Wisconsin Department of Transportation

1020-05-63, WISC 2027009
Menomonie – Eau Claire
Wilson Creek to Red Cedar River
IH 094
Dunn County

1021-01-78
Baldwin - Menomonie
East Br Wilson Cr Bridge B-17-0051
IH 094
Dunn County

This is Addendum No. 02, which provides for the following:

PROJECT NO: 1020-05-63	HWY: IH 94	COUNTY: DUNN	TYPICAL SECTIONS	SHEET 14	E

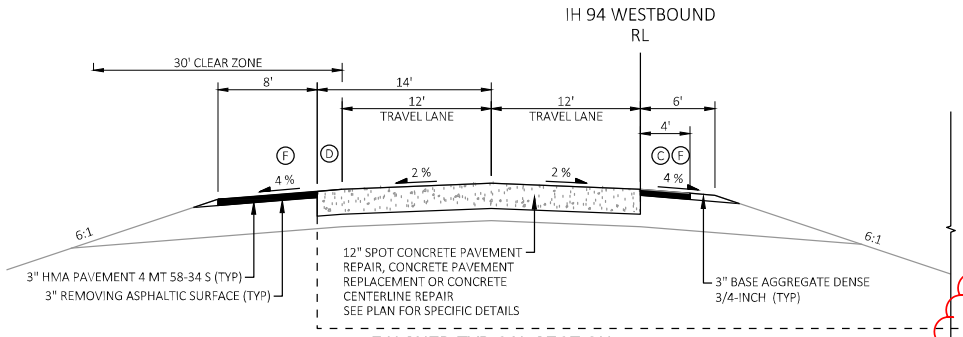
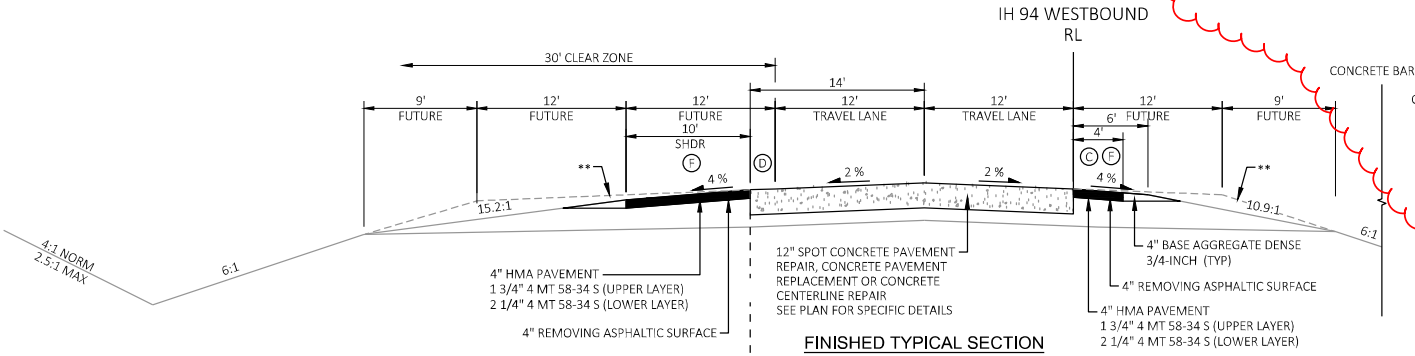
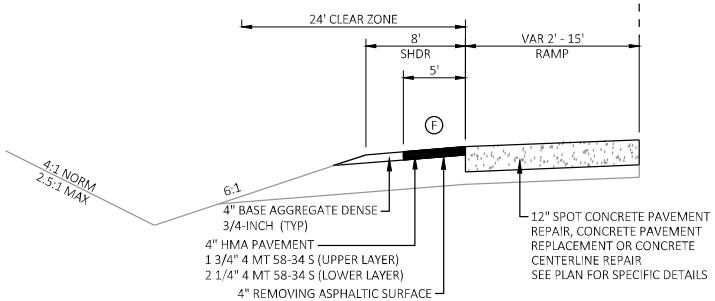
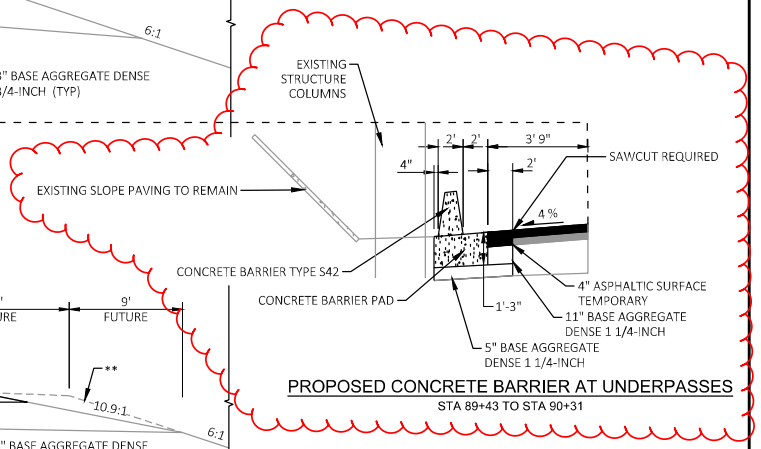
Revised Plan Sheets	
Plan Sheet	Plan Sheet Title (brief description of changes to sheet)
2	General Notes (remove CenturyLink utility contact information/add note about CenturyLink labels in the plan. Correct the name of Level 3 Communications LLC)
14	Finished Typical Section (added Wilson Street bridge slope paving/concrete barrier)
16	Finished Typical Section (added Wilson Street bridge slope paving/concrete barrier)
47	Construction Detail – STH 25 Temporary Crossover (Edited median removal hatch)
105	Traffic Control Overview (updated pavement marking removal note)
118	Traffic Control IH 94 – Stages 1 and 3 (removed pavement marking removal X's)
122	Traffic Control IH 94 – Stages 1 and 3 (removed pavement marking removal X's)
124	Traffic Control IH 94 – Stages 1 and 3 (removed pavement marking removal X's)
125	Traffic Control IH 94 – Stages 1 and 3 (removed pavement marking removal X's)
126	Traffic Control IH 94 – Stages 1 and 3 (removed pavement marking removal X's)

PROJECT NO: 1020-05-63	HWY: IH 94	COUNTY: DUNN	TRAFFIC CONTROL IH-94 - STAGE 2	SHEET 127	E

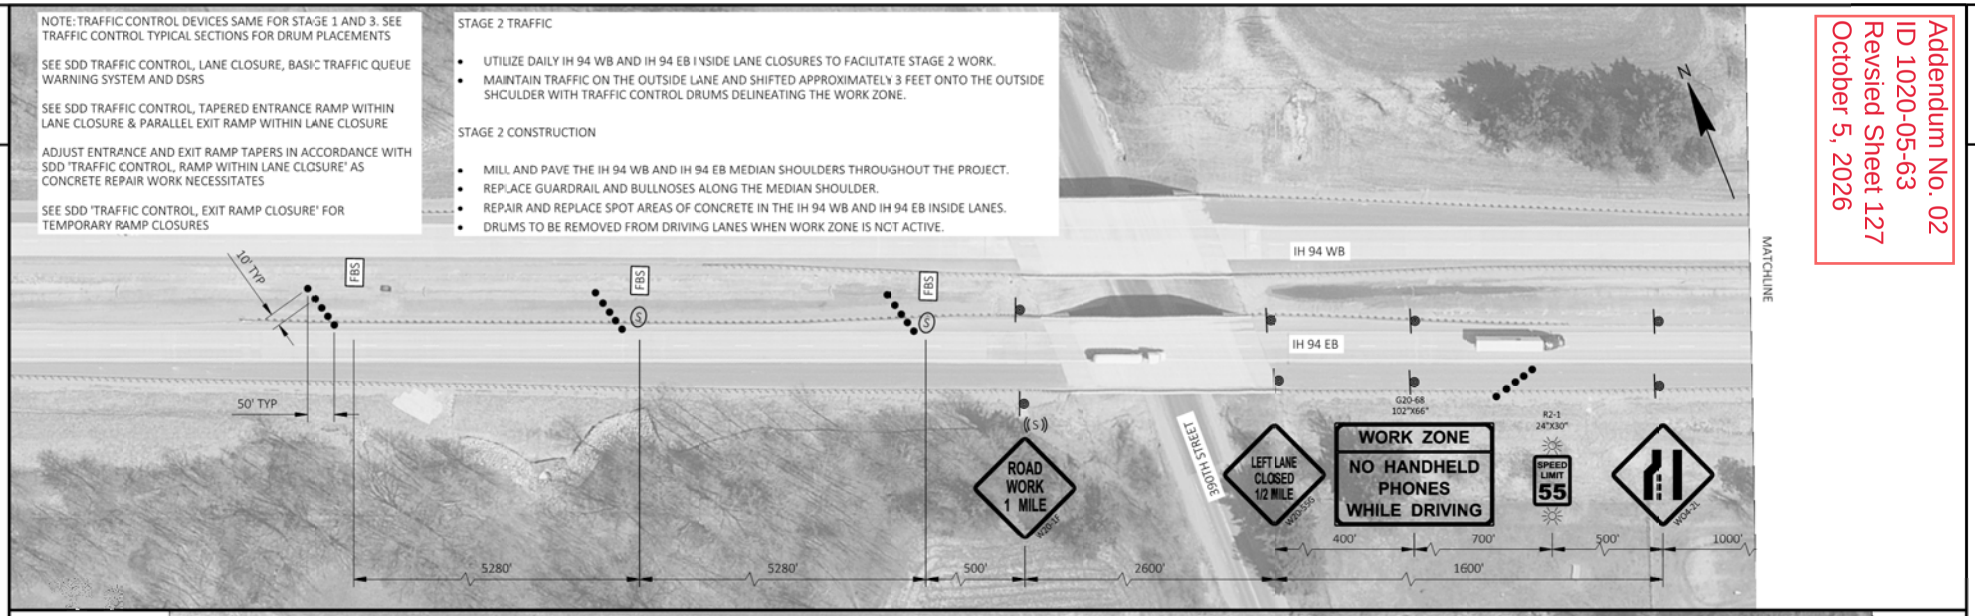
127	Traffic Control IH 94 – Stages 2 (removed pavement marking removal X's)
134	Traffic Control IH 94 – Stages 2 (removed pavement marking removal X's)
135	Traffic Control IH 94 – Stages 2 (removed pavement marking removal X's)
161	Miscellaneous Quantities (Updated Base Aggregate Dense 1 ¼-Inch, Removing Concrete Pavement, Removing Asphaltic Surface, Excavation Common, and Borrow)
162	Miscellaneous Quantities (added Additional Quantities Elsewhere Asterisk)
163	Miscellaneous Quantities (Updated Asphaltic Surface Temporary and Sawing Asphalt quantities)
164	Miscellaneous Quantities (Added Excavation Common and Borrow in the For Information Only section of the Barrier Grading Shaping Finishing table)
176	Miscellaneous Quantities (Removed and updated Marking Line Removal quantities, added Slope Paving Crushed Aggregate quantity)
178	Plan Sheets (updated note on Culvert pipe at Station 37+94 to show Reset and Retie End Section item)
